Statement

Product Name: LTE Cat M1/Cat NB2/EGPRS Module

Model Number: BG95-M3

Hardware Version: R2.1

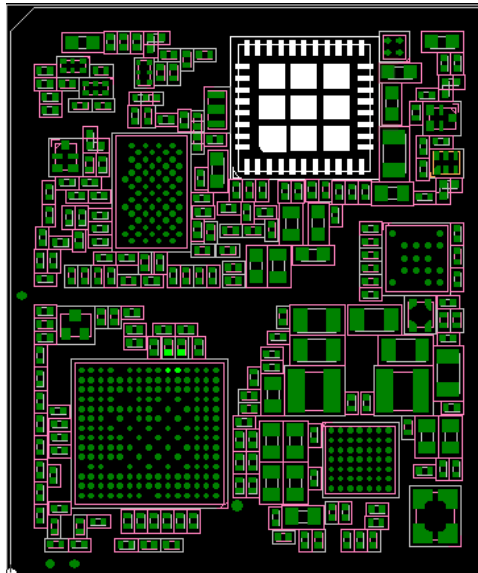
There is no difference in HW design, we just replace a new PA and the other parts are the same, the details are shown as following pictures and table.

Designator	Original (Part Description)	New (Part Description)
U603	IC RF SWITCH SP10T + GSM Qualband 5.3x5.5mm H0.905mm RO (VC7912-61)	IC RF SWITCH SP14T 36dBm & PA GSM Quadband TDD34/39 5.3x5.5mm H0.94mm RO (RR88916-81H)

The change will not impact RF performance of CatM1/ NB-IoT/EGPRS.
